**COUNTY OF SAN MATEO
PLANNING AND BUILDING DEPARTMENT
CORRECTION LIST**

Date: 4/2/18
New single story 12,425 sq ft essential services fire station including 7 bunk rooms, 3 drive through apparatus bays, kitchen, dining room, day room, training room, offices, turnouts, fitness room, extractor, laundry, and storage rooms, 72 hour run generator and fueling tank and trash and recycling containment - "El Granada Fire Station"

Address: 0 Obispo Rd.

PC#: BLD2017-01821

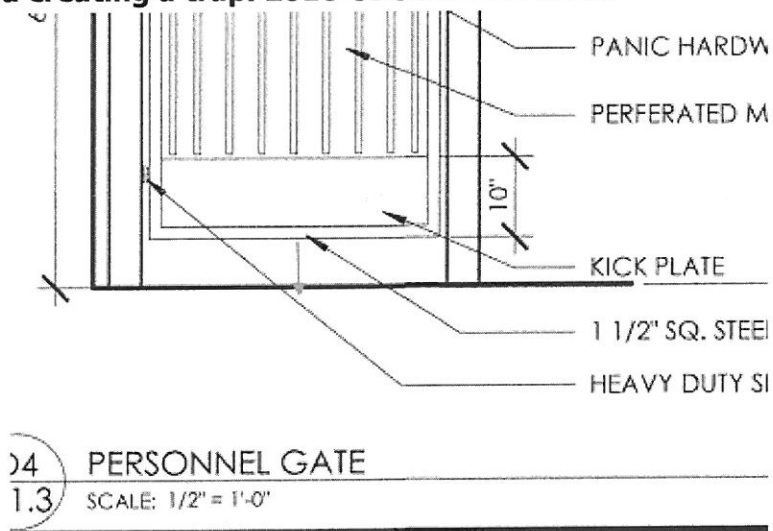
35.6. Along accessible routes, when path of travel crosses or adjoins vehicular way, show that the boundary between the path of travel and vehicular way is separated by curbs, railing or truncated domes per CBC 11B-247.1.2.5.

2nd Review Comment: Sheet A1.1: Please revise site plan to show truncated dome at the boundary between the path of travel and the vehicular way (including the path to the trash enclosure).

3rd review comment: Sheet A1.1; graphically show accessible route from the EV van accessible parking spaces to the accessible entrances of the building. Amend plans to show truncated domes accordingly. CBC 11B-812.5
